Chiller Replacement – 2025
Project No. 24036

ADDENDUM NO. 1

April 15, 2025

Sheet MP.110

MECHANICAL PIPING PLANS

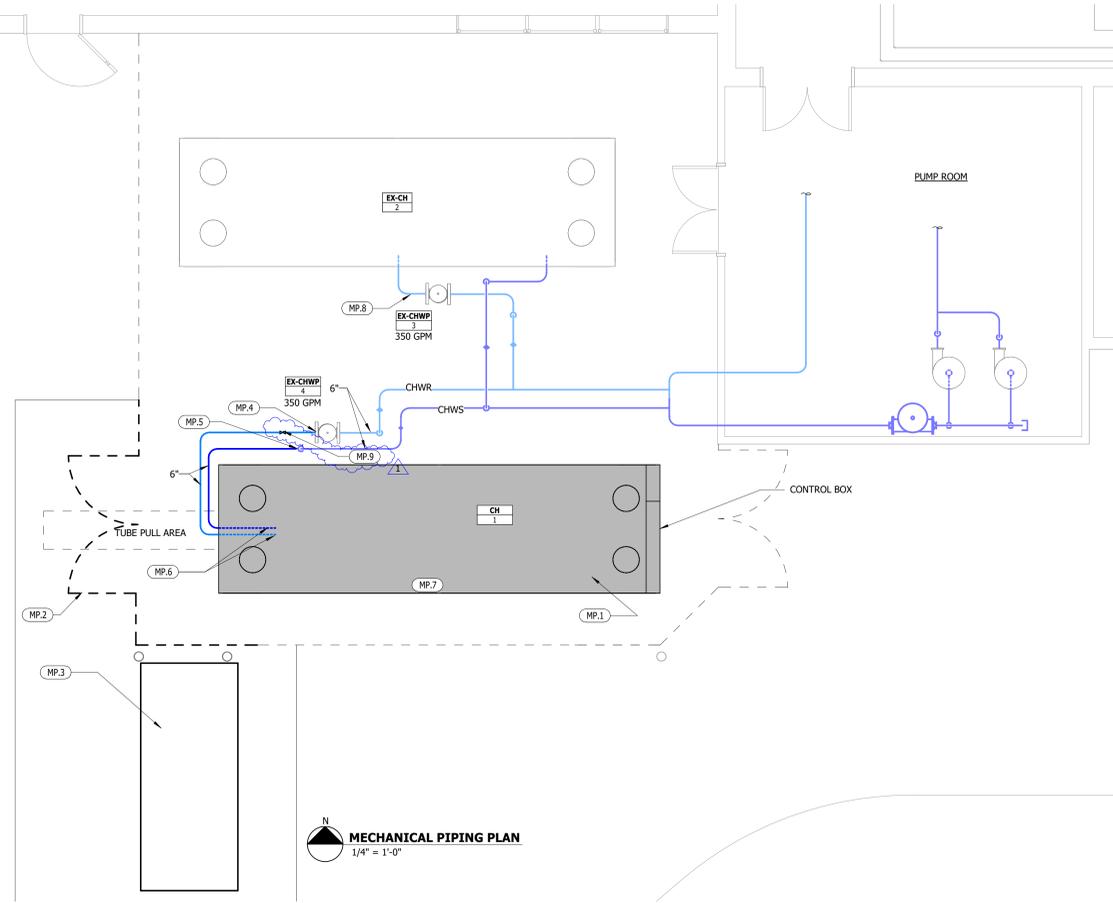
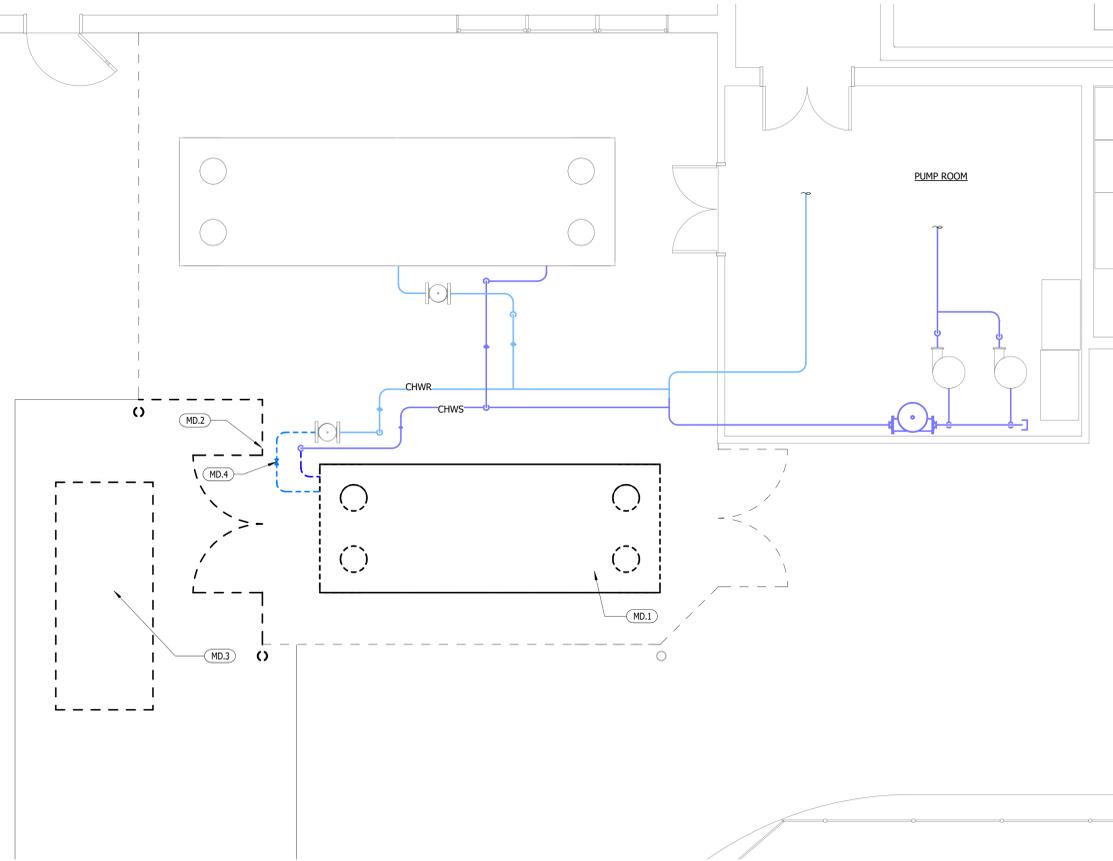
1. The scope of work regarding the existing triple duty valve has been clarified.

- MD.1 REMOVE EXISTING CHILLER, SUPPORT STRUCTURE, AND PIPING. SEE STRUCTURAL AND ELECTRICAL DRAWINGS FOR ADDITIONAL WORK.
- MD.2 SEE STRUCTURAL DRAWING FOR REWORK OF FENCING.
- MD.3 EXISTING TRASH DUMPSTER TO BE RELOCATED BY OWNER.
- MD.4 EXISTING TRIPLE DUTY VALVE TO BE RELOCATED.
